# ADDENDUM NO. 1

**June 13, 2024**

## **PORTER COUNTY HIGHWAY DEPARTMENT – CENTRAL FACILITY**

This Addendum consists of Page ADD 1-1 through ADD 1-4, revised Specification Section 00 20 00 – Information Available to Bidders, attached Addendum No. 1 from A & Z Engineering, consisting of 1 page and 8 drawings, and attached Addendum No. 1 from MartinRiley, consisting of 4 pages, Specification Sections 00 01 10 - Table of Contents, 07 42 13 – Metal Wall Panels, 07 71 00 - Roof Specialties, 10 28 00 - Toilet, Bath, and Laundry Accessories, 11 11 19 - Vehicle Lubrication Equipment, 23 31 00 - HVAC Ducts and Castings, 41 22 00 - Hoists and Cranes, and 13 Drawings.

**A601**

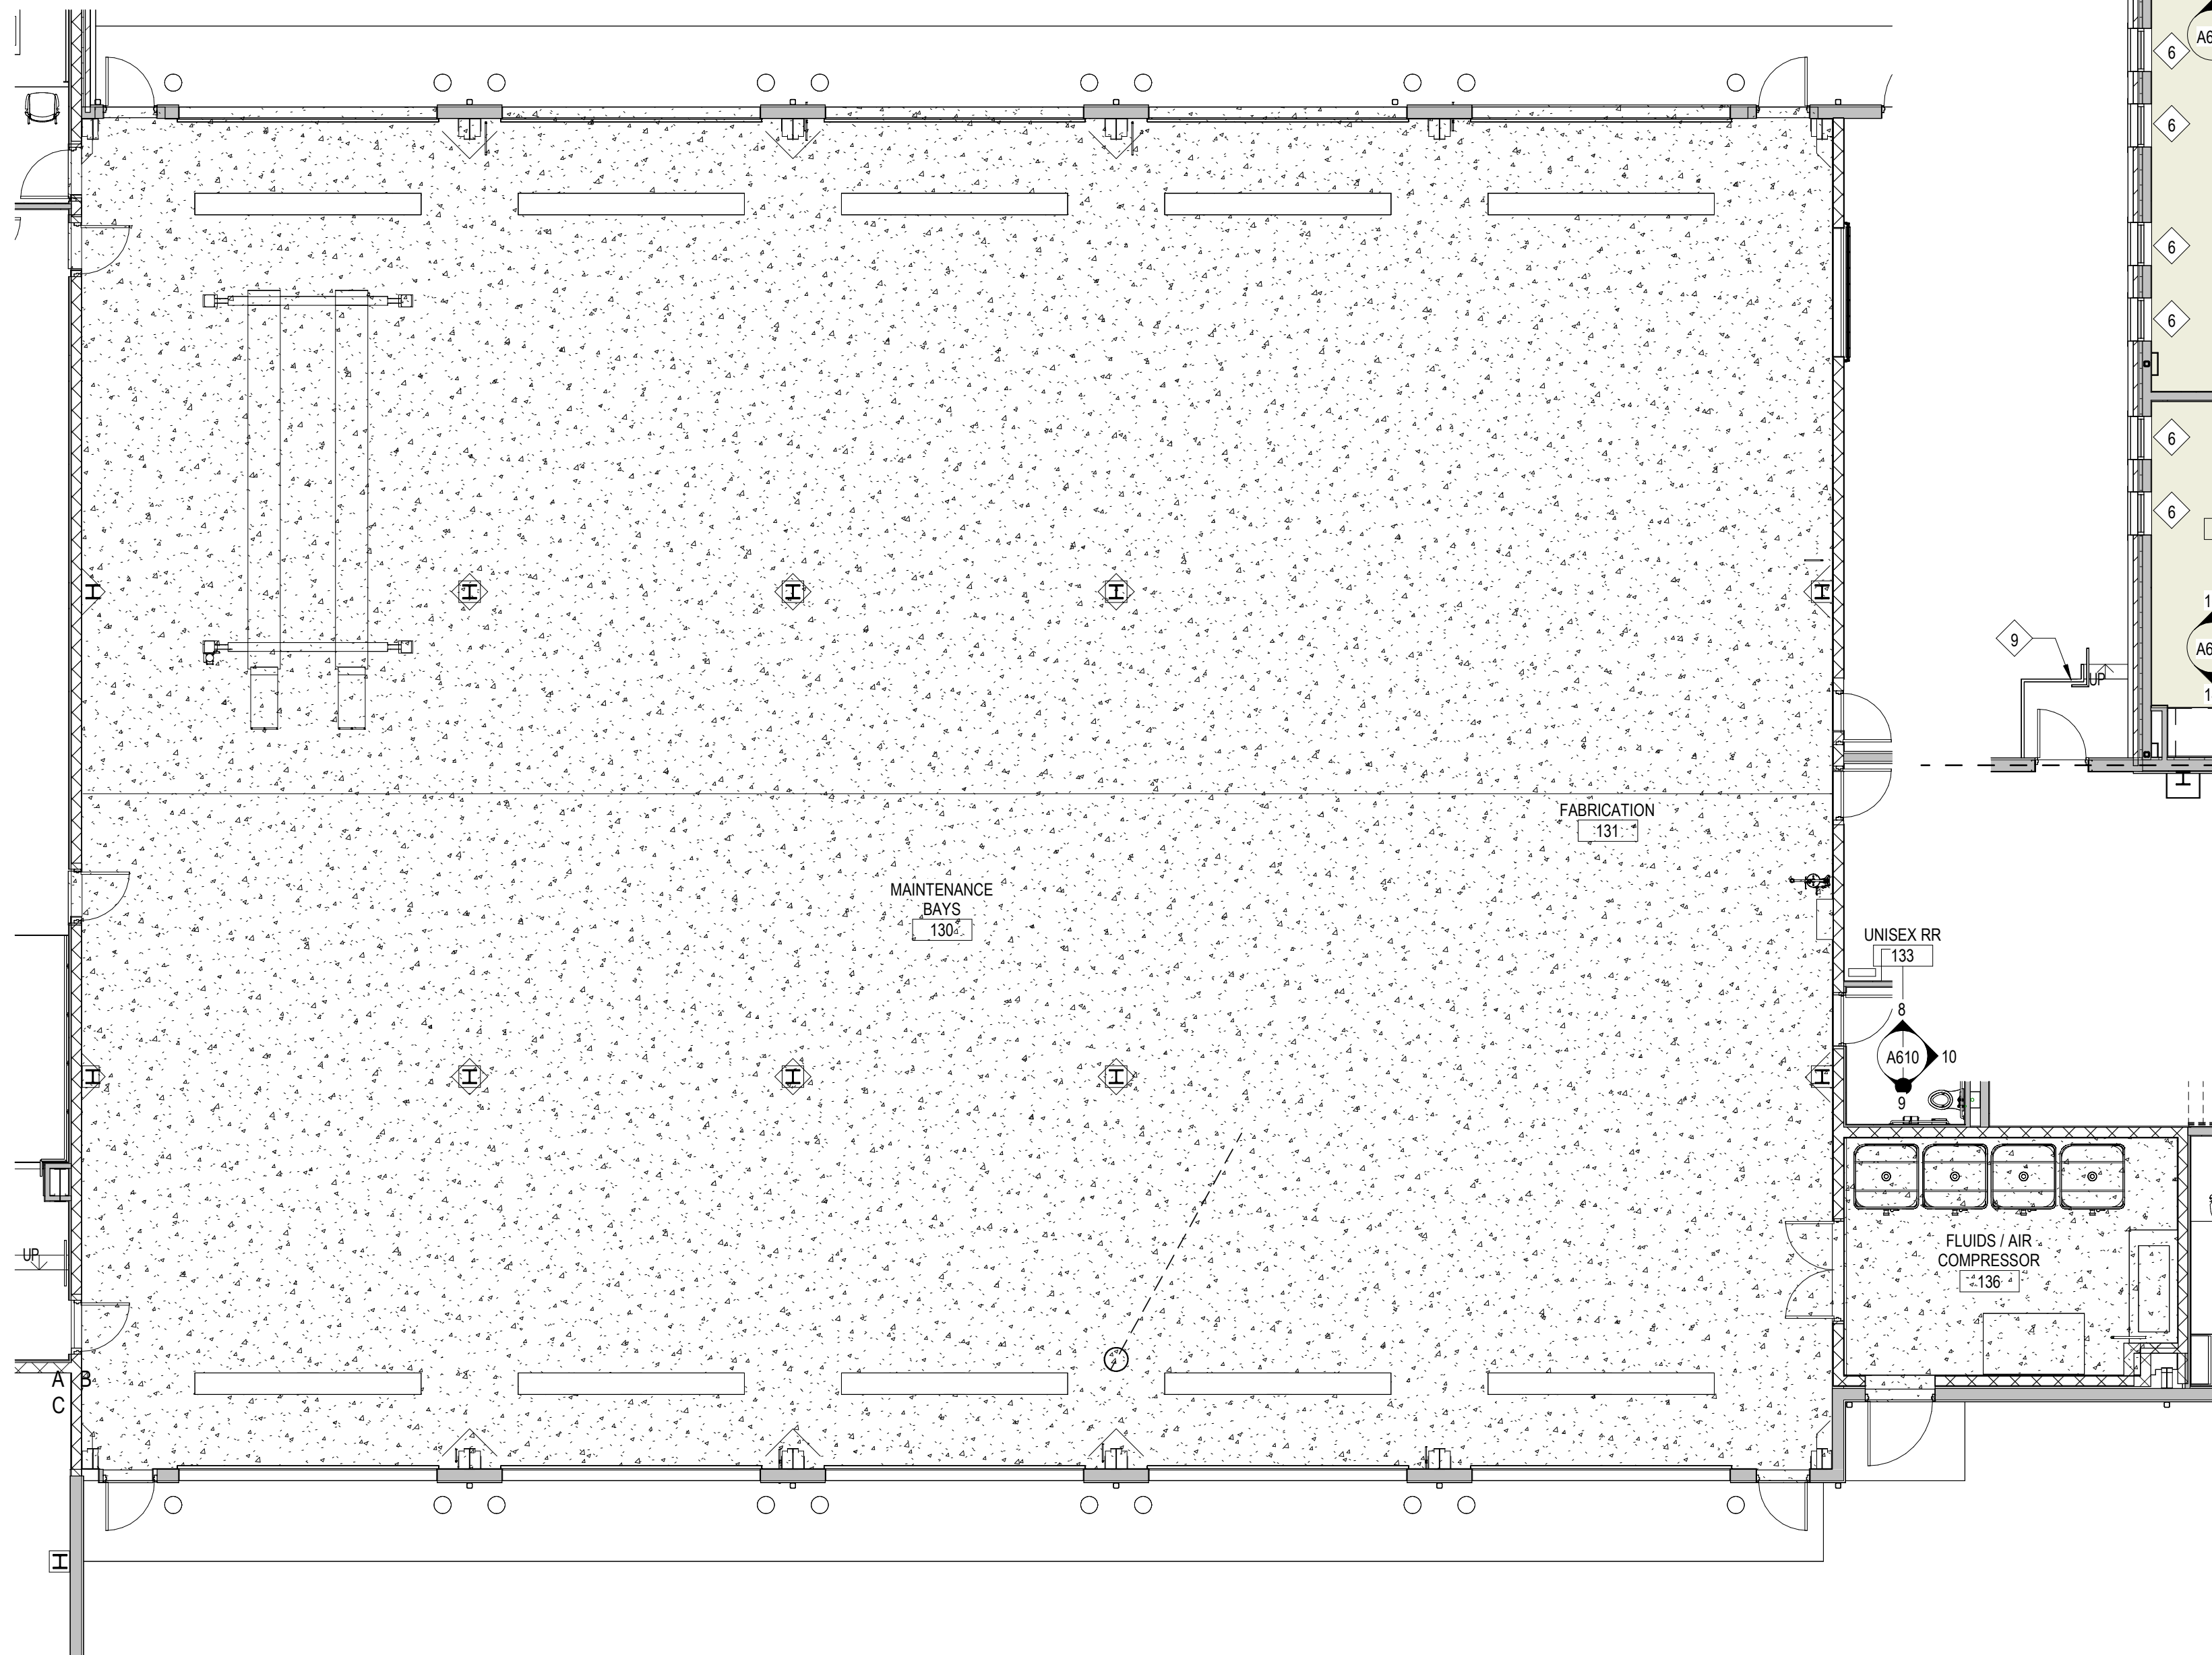
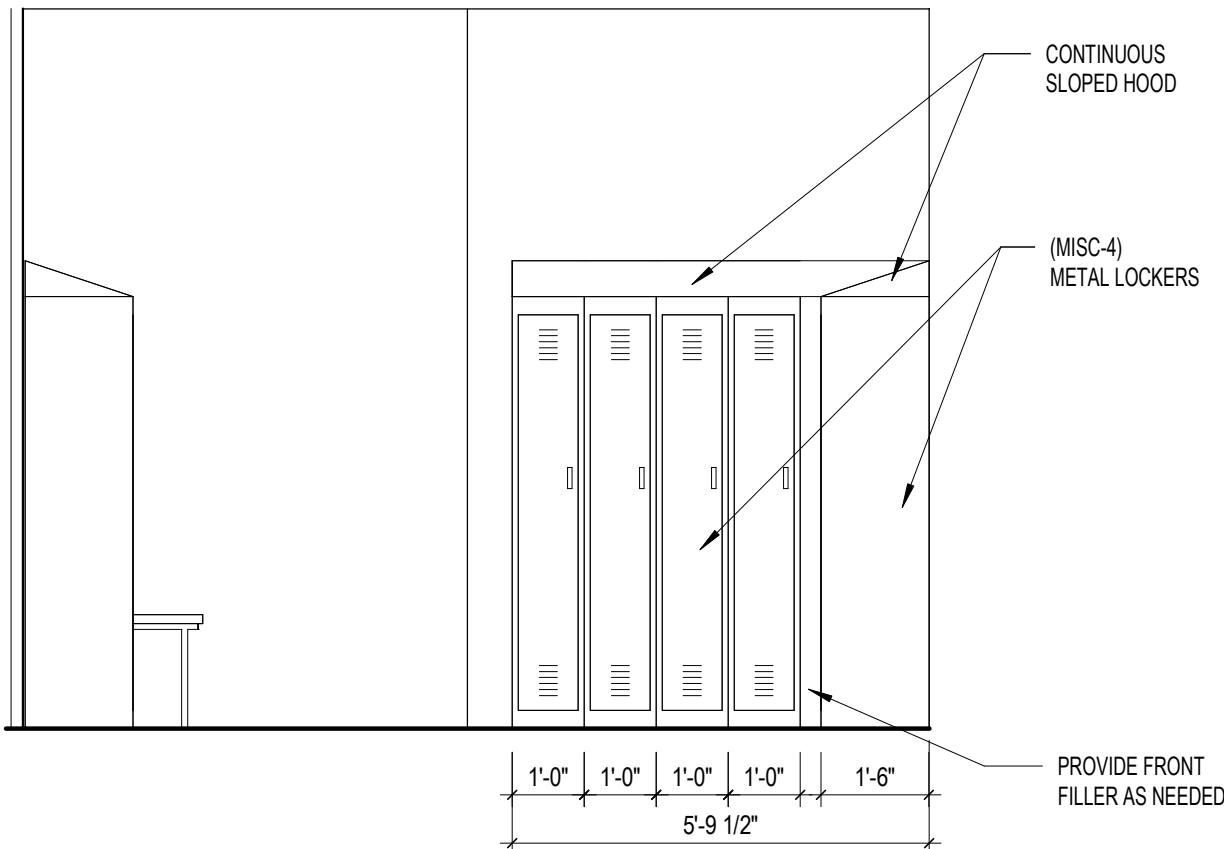
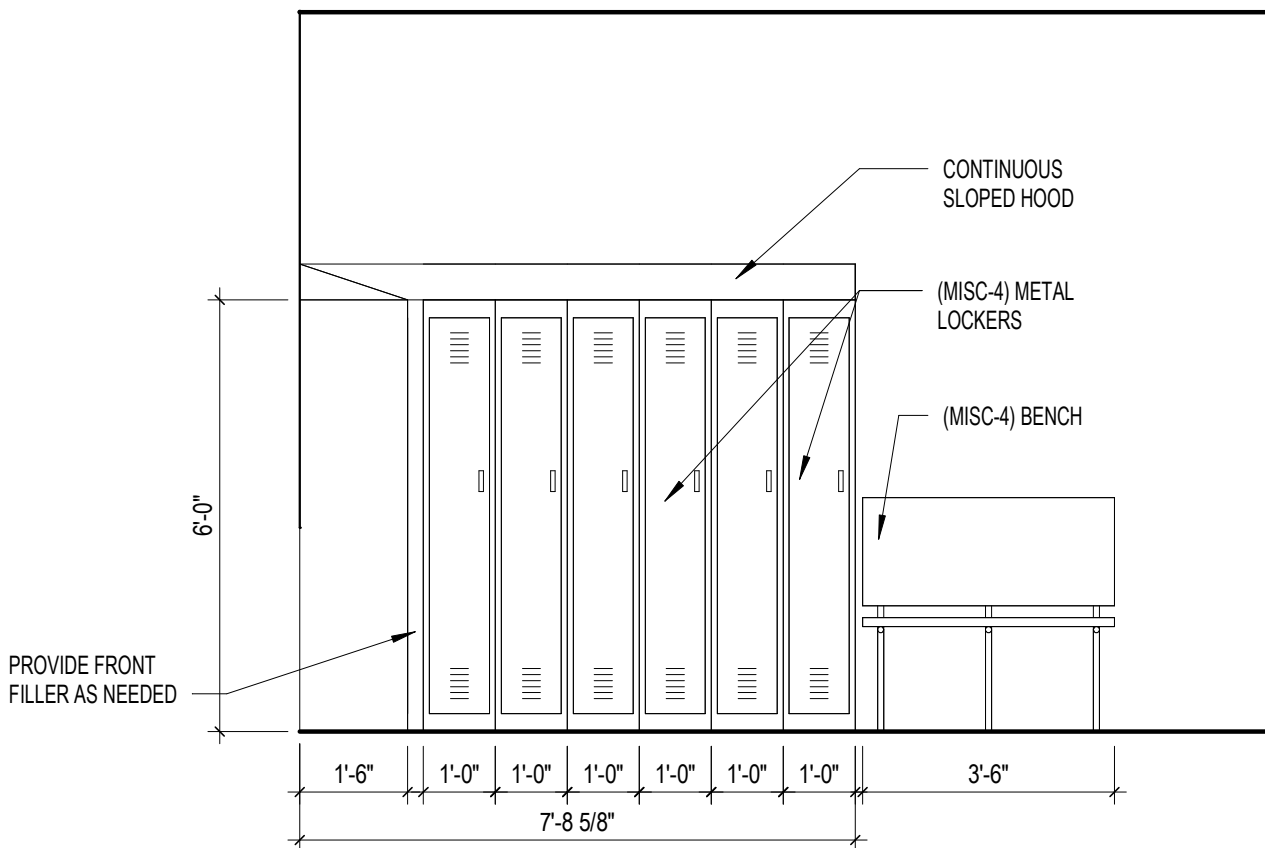
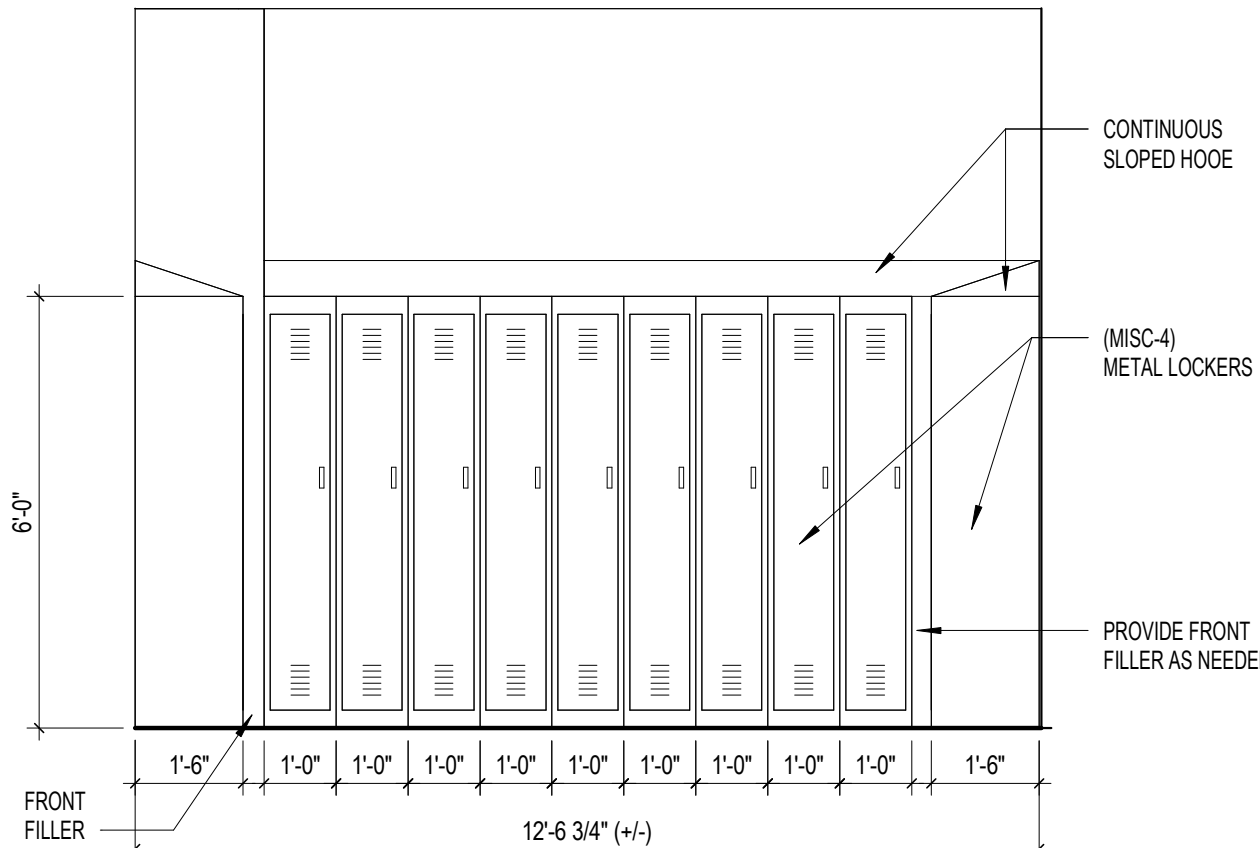
Sheet A601 Room Finish Schedule and Interior Elevations **DELETE** Rooms 110, 111, and 112 from Room Finish Schedule.

Sheet A601 Room Finish Schedule and Interior Elevations **MODIFY** Room Finish Schedule line item 105 to indicate "CPT-1" floor finish.

Sheet A601 Room Finish Schedule and Interior Elevations **MODIFY** Room Finish Schedule line item 109 to indicate "CPT-2" floor finish.

Sheet A601 Room Finish Schedule and Interior Elevations **MODIFY** Room Finish Schedule line item 121 to indicate "R-1" floor finish.

**7** Base Flashing  
3" = 1'-0"

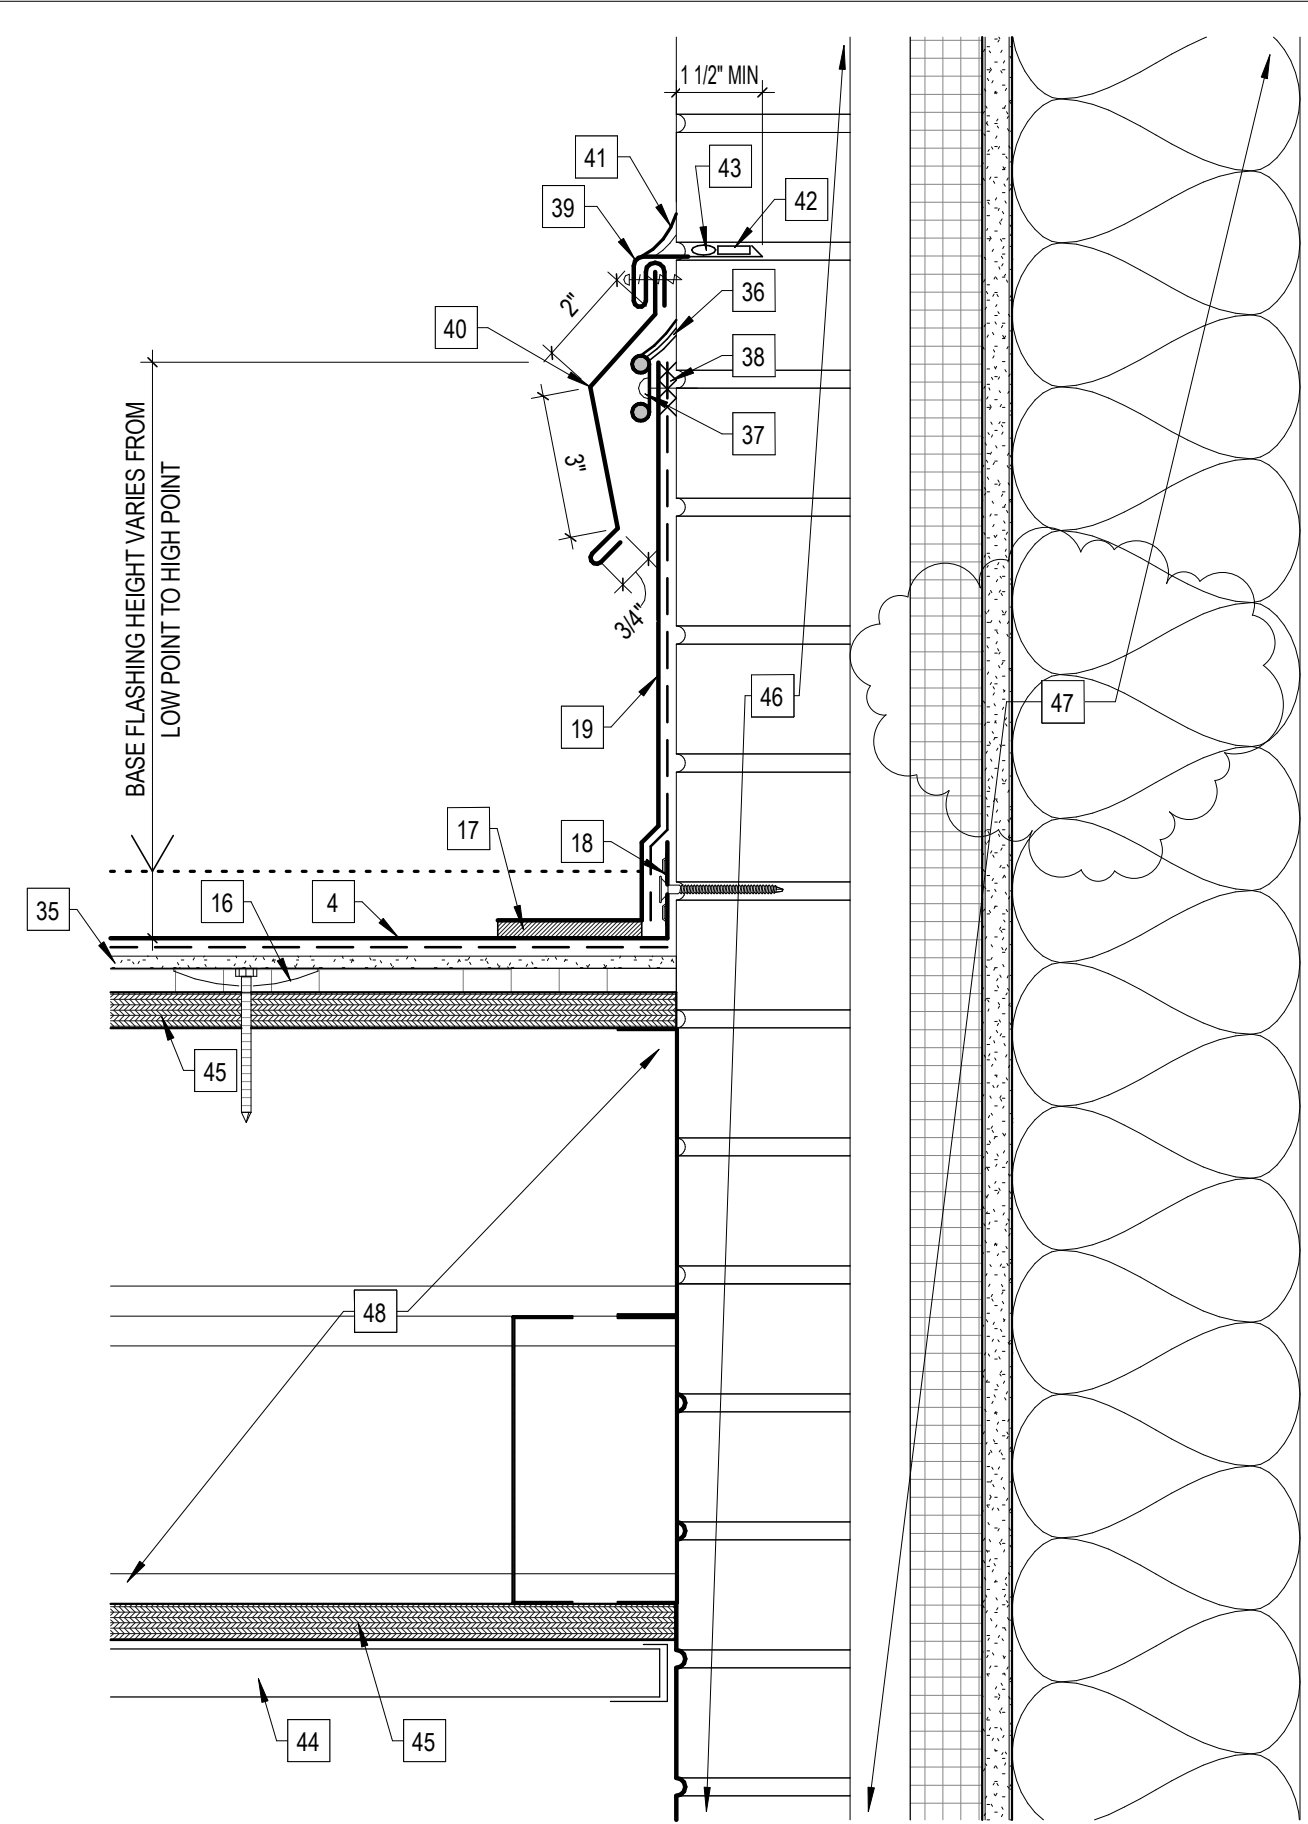
Sheet R201 Roof Details **MODIFY** Detail 7 to remove Work Description Note 48 and move Work Description Note 47.
